NOTICE OF PROPOSED CHANGE IN PROPERTY

PETITION NO. 540
 U of D JESUIT HIGH SCHOOL
 8400 SOUTH CAMBRIDGE AVE.
 DETROIT, MICHIGAN 48221
 C/O KARL KISER, S.J.
 PHONE NO. 313 862-5400

B					REQUEST TO CONVERT TO EASEMENT A PORTION OF CAMBRIDGE AVE. 50 FT. WD. IN THE BLOCK BOUND BY OHIO, CHERRYLAWN AVE., SEVEN MILE RD. W. AND OUTER DR. W.	CITY OF DETROIT CITY ENGINEERING DEPARTMENT SURVEY BUREAU
	A					
DESCRIPTION		DRWN	CHKD	APPD	DATE	JOB NO. 01-01
REVISIONS						DRWG. NO. X 540
DRAWN BY WLW		CHECKED				
DATE 02-13-15		APPROVED

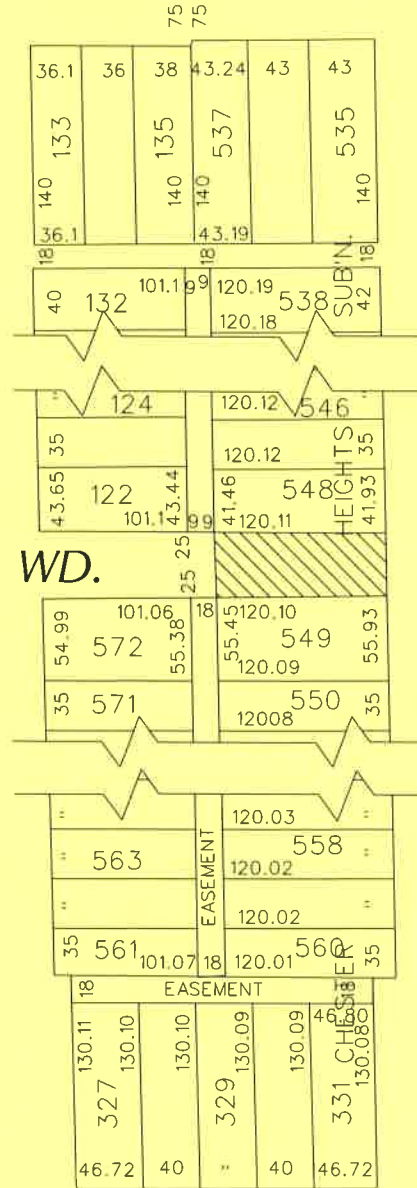
A street light feed is located in the proposed easement area. Maintenance trucks may require access. Installation of a gate is suggested.
